Approval of Reserved Matters Consultation

Application Number: 250819

Site Address: Finchwood Park, Sheerlands Road, Arborfield, Wokingham, RG40 4QY

MEMORANDUM

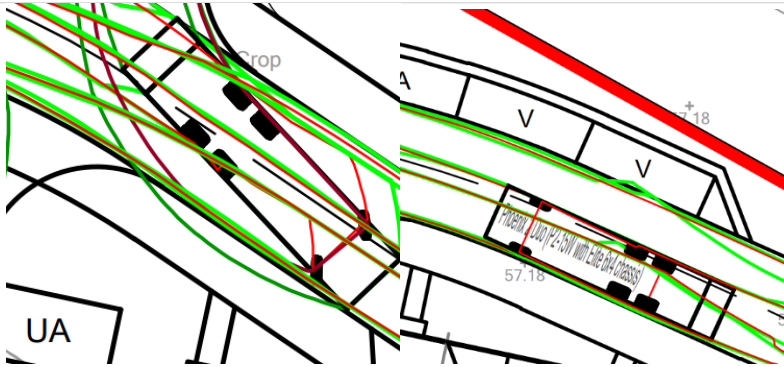
13. The LHA also require further information is included with the swept path analysis:

- Details of vehicle speed used for tracking of all vehicles.
- Details of clearance between wheels and kerbface. 300mm clearance required between wheels and kerbface.
- Large car measuring c.5.0m long and c.1.9m wide. The car tracked measures 1.769m wide and 4.8m long, which is narrower and shorter than many modern cars.
- Fire Tender tracking for a [Royal Berkshire Fire Service Volvo F8](#) which measures 8.51m long x 2.46m wide. The applicant has shown a DB32 Fire Appliance which only measures 2.18m wide.

a) The LHA are satisfied with the submitted vehicle speed, confirmation that vehicles can pass each other with 300mm clearance and revised tracking showing the correct fire tender for the Royal Berkshire Fire Service.
